**ADDENDUM#2**

**TITLE: CITY OF BELLE GLADE AIRPORT
TAXIWAY CHARLIE CONSTRUCTION
FDOT AGREEMENT #442706-1-94-01**

ADDENDUM 2

RE: *Taxiway Charlie Construction Project*
Belle Glade State Municipal Airport (X10)
FDOT Project Number: 442709-1-94-01

DETAIL - DEMUCKING LIMITS

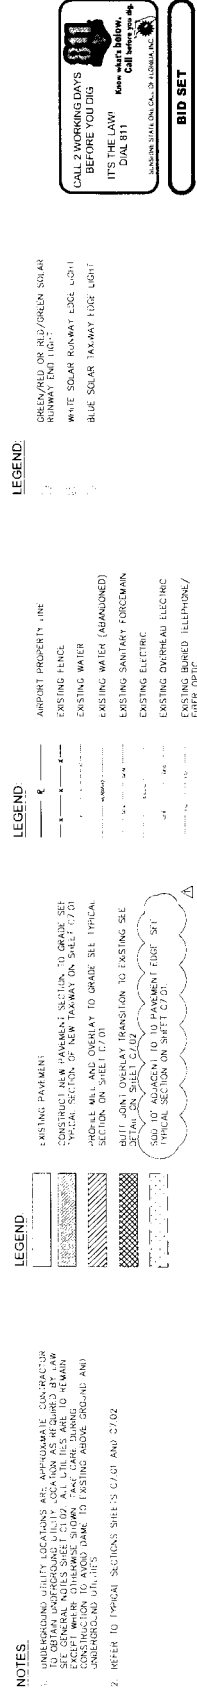
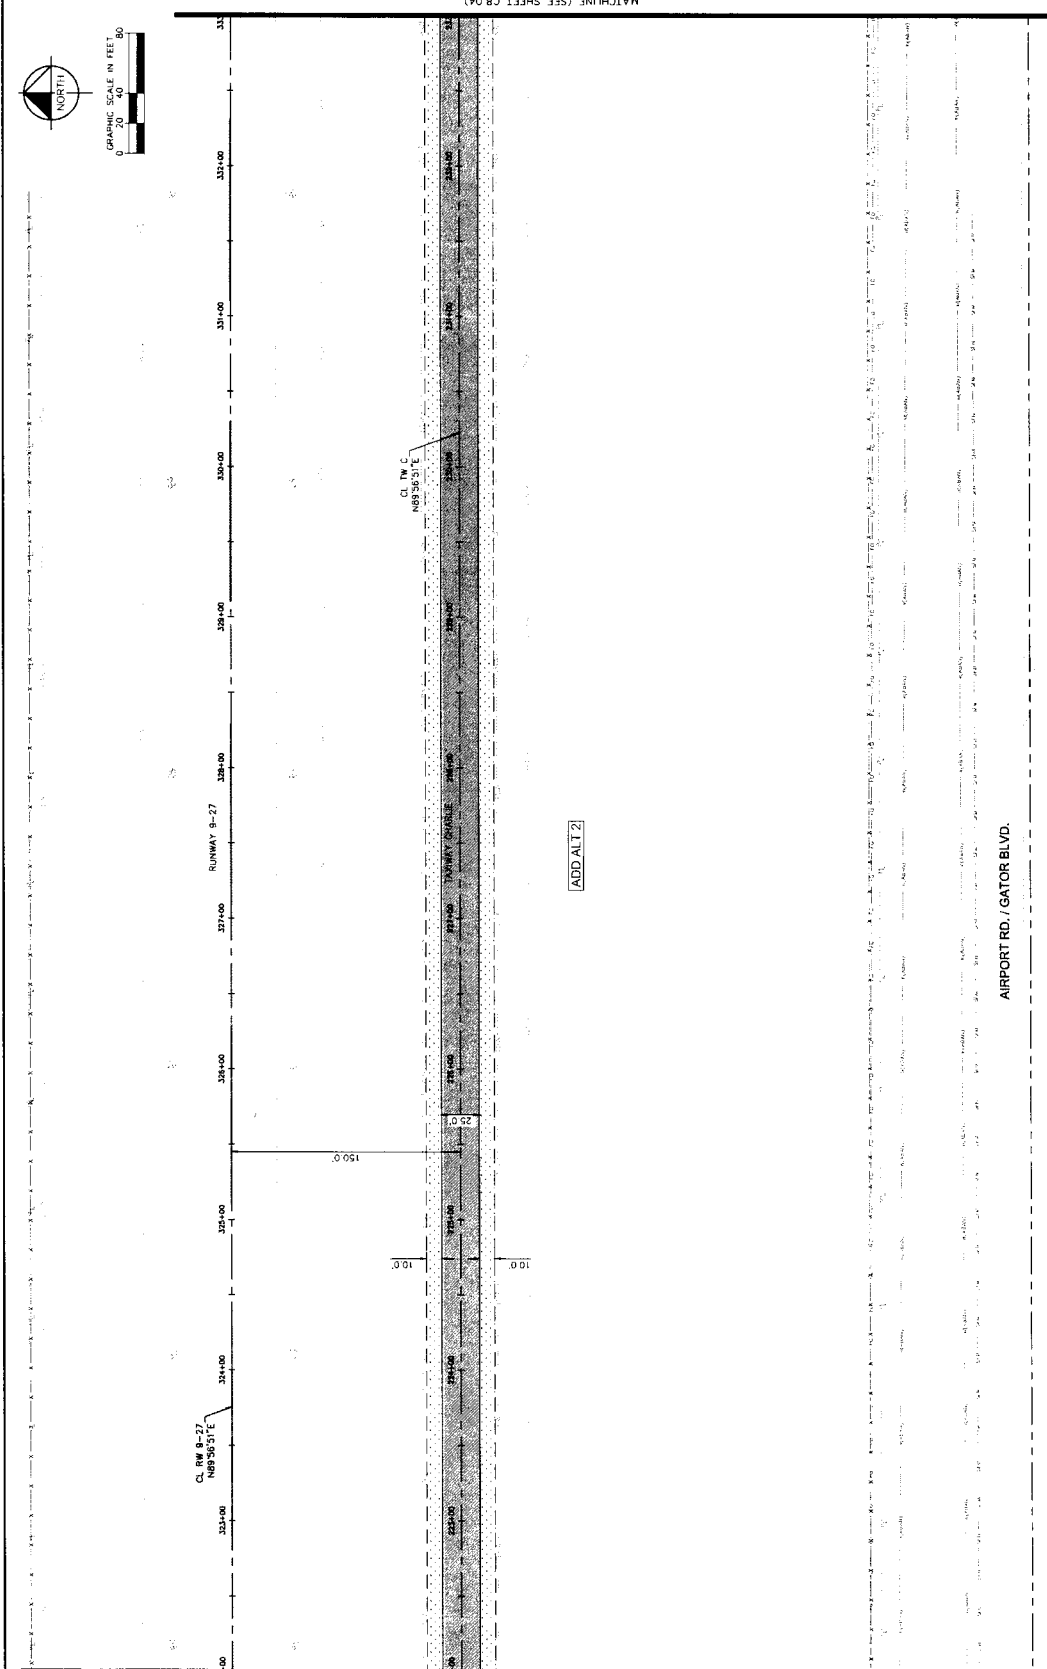
2. Is the 10' sodded shoulder a LBR40 stabilized shoulder as shown on sheet C7.01(Typical section of new taxiway) and if so, is the stabilized subbase incidental to the sod or will the 8" subbase quantity be increased to reflect the additional quantity?

3. Sheet C7.01 Detail – Demucking Limits: The section shows the removal to existing limerock. Sheets 2 and 3 show "Light Brown Clayey Limestone" but the legend simply says limestone. Is this the depth we are required to remove the muck to? Also, there are 3 bores that show the limestone hatch, but a clay beneath that and then more limestone. Are we to remove the material to the first limestone depth, or to the second?

- Revisions to Typical Section on Sheet C7.01 in the Plan Set to remove the P-154 Stabilized Shoulder
- Revisions to Sheets C8.01-C8.04 and C9.01-C9.04, in the Plan Set to remove mention of P-154 Stabilized Shoulders.

- a. **The 10' P-154 area beneath the shoulder sod has been removed for the typical section on sheet C7.01. See revised typical section in attached Addendum 2. Also, all mention of the P-154 stabilized shoulder has been removed from the plan set, see attached Addendum 2.**

In the example posed, "Light Brown Clayey Limestone" would be the correct material limit to remove the muck layer to. The intent of the demucking is to remove all organic and muck material from the areas that the new taxiway and shoulders will be constructed on. Once the contractor has removed the organic material and reaches the first layer of limerock or material that is not considered organic muck, the demucking is deemed by the RPR to be completed and the excavation process will be complete.
4. Phase 1 shows a duration of 4 days. There is no core information in this location. Can we assume there will be no demucking in this location? If we will need to demuck this area I do not believe 4 days is enough time.
